PLANNING NMA-CHANGE LIST		
ID	Proposed Changes to plans that are 'Non Material'	Reason for 'Amendment'
A	Changes to Common stair towards compliance for general access where a clear landing needs to be provided and to accommodate smoke control. Circulation area and internal doorway to stairs rearranged to adapt corridor aisle. Stairs, structurally stacked for construction leading towards the corridor or lobby next to the stair being provided with a smoke vent and a store area provision on ground level. Rearrangement in plan due to the above visible on the Northeast facade. Window openings, adapted to suit mentioned changes/rearrangement.	Compliance towards Building Regulations, Part-K-Protection from falling, collision and impact and Part-B-Fire safety
B	Changes to Communal lifts and stairs towards compliance for firefighting where a firefighting shaft is required as the building is over 18m and to accommodate smoke control and building services. Circulation area internal doorway to stairs and clear landing for lifts rearranged to adapt corridor aisle. Stairs, structurally stacked for construction leading towards a vertical smoke shaft that opens at roof level with rationalised comm

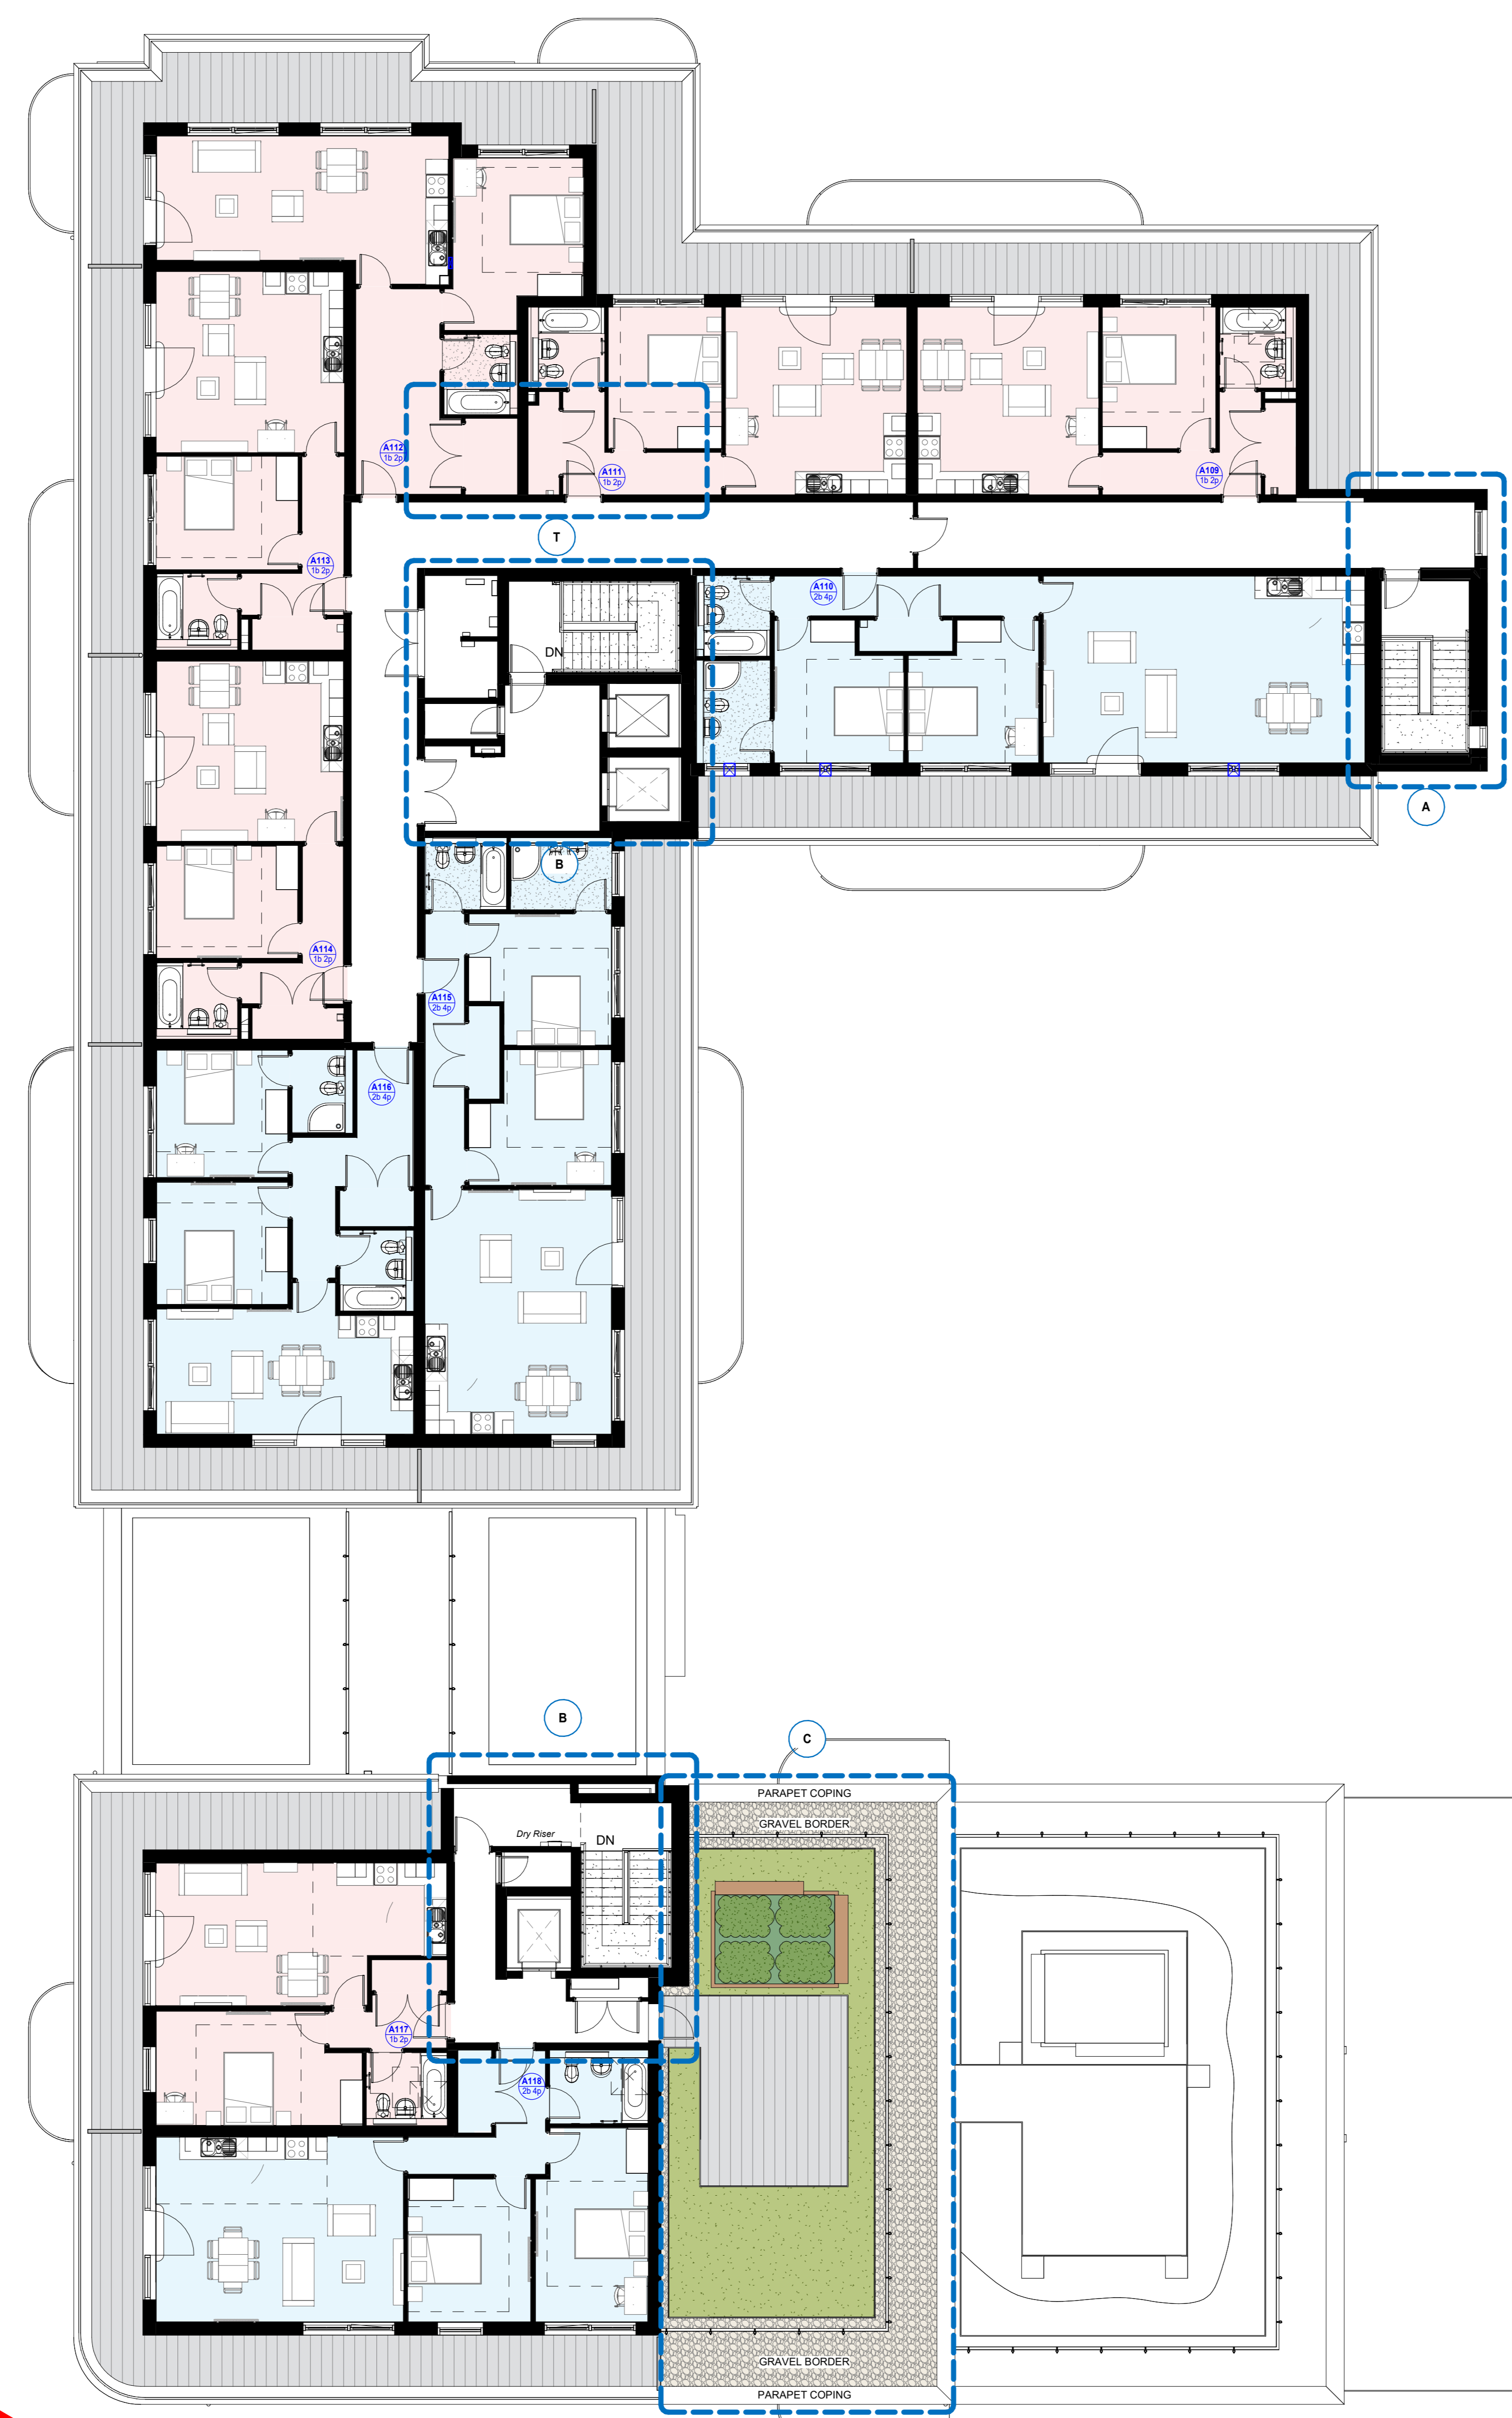
C	Changes to communal roof gardens (landscaping) including change of barrier type (railing) from glazed balustrade to counterbalance metal railing.	To contribute positively towards biodiversity via balance of soft and hard landscaping schemes including provisions for bird and bat boxes, whilst maintaining overall uniformity for railing type
D	Removal of photovoltaic (PV) cells on the roof	PV was not required as Part L requirement was met using Exhaust Air Heat Pumps
E	Relocation of Substation and provision for Generator in allocated space.	Provision for separate secluded area for generator
F	Changes to provide new location for UKPN Substation	Provision for future relocation for UKPN Substation
G	Changes to ground level Cycle store to accommodate building services plant rooms including removal of two openings with rearrangement of the remainder openings.	Provision towards Building Services, Secondary LV switch room and Comms room.

H	Changes to ground level Cycle store to accommodate building services plant rooms including removal of two openings with rearrangement of the remainder openings.	Provision towards secure access and splitting into 4 small bin stores to comply with recent update of having maximum 8 large (1100lts) receptacles within.
J	Removal of Cycle store area and Bin store area at ground level, including external door in cycle store area towards provision to accommodate building services plant room including clear vehicular access towards undercroft parking.	Provision towards Building Services, Primary LV switch room and vehicular access towards undercroft parking.
K	Changes to ground level facade including removal of two openings to accommodate communal letter boxes with rearrangement of the remainder openings with provision for accessibility.	Provision towards communal letter boxes
L	Removal of undercroft parking entrance/exit at ground level towards provision for Relocation/Retainment of existing UKPN Substation, whilst adding double doors as per change ID C-05.	Provision towards single point of entry/exit for undercroft parking and towards relocation/retainment of existing UKPN Substation mentioned in change ID-E.

M	Changes to ground and first floor level, Common stair for means of fire escape and to accommodate smoke control to circulation area. Circulation area and internal doorway to stairs rearranged to adapt corridor aisle. Stairs, moved away from corridor aisle leading towards provision for an external smoke vent at first floor level. Rearrangement in plan due to the above visible on the Northeast facade. Ground level escape door, adapted to suit mentioned changes/rearrangement.	Compliance towards Building Regulations, Part-B-Fire safety.
N	Changes to ground level Cycle room and adjacent Store to replace provision for Cycle store area as per change ID C-09 via consolidation. Rearrangement in plan due to the above visible on elevations.	Provision towards replacement of removed cycle store mentioned in change ID-J.
P	Changes to Communal lift and stairs towards compliance for general access where a clear landing needs to be provided and to accommodate smoke control and building services. Circulation area internal doorway to stairs and clear landing for lifts rearranged to adapt corridor aisle. Stairs, structurally stacked for construction leading towards covered and enclosed stair at roof fourth floor level with rationalised communal entrance/exit. Rearrangement in plan due to the above visible on elevations.	Compliance towards Building Regulations, Part-K-Protection from falling, collision and impact, Part-B-Fire safety and Provision for stair enclosed/walkway that is directly covered.

Q	Changes to ground level Bin store arrangement to replace Bin store as per change ID C-09 via consolidation and enlargement to provide building services plant room. Rearrangement in plan due to the above visible on elevations.	Provision towards replacement of removed Bin store mentioned in change ID-J and provision for BCW Tank room
R	Changes to ground level openings, facade screens from circular pattern metal screens/vents to vertical extruded aluminium flats metal screen that match the railing type, including removal of one opening that clashes structural column on the corner way elevation.	To maintaining overall architectural uniformity and structural framing.
S	Removal of Green Wall as they do not comply with fire safety regulation 7(2).	Regulation 7(2), requires all residential blocks with top storey heights over 18m to have all materials which become part of an external wall or specified attachment (e.g., balconies) to achieve class A2-s1, d0 or class A1, except for materials which are exempt as per regulation 7(3). Additionally, membranes used as part of external wall construction above ground should achieve a minimum of class B-s3, d0.

T	Changes to storage area, rearrangement towards desired storage required.	Provision towards desired storage required.
U	Discrepancy error on Comet way elevation whereby two window openings depicted would not have been located on the fifth-floor level plan as these would intrude privacy for the bathrooms.	Discrepancy error
V	Removal of single window, recessed brick reveals on the Northeast elevation.	The recessed brick reveals is towards the left of a single pane window for levels 1-4, whilst it changes to a double pane for level 5. To maintain architectural uniformity, we have detailed a constant double pane window for all levels.
X	Private path on western site boundary	For Façade maintenance MEWP access.
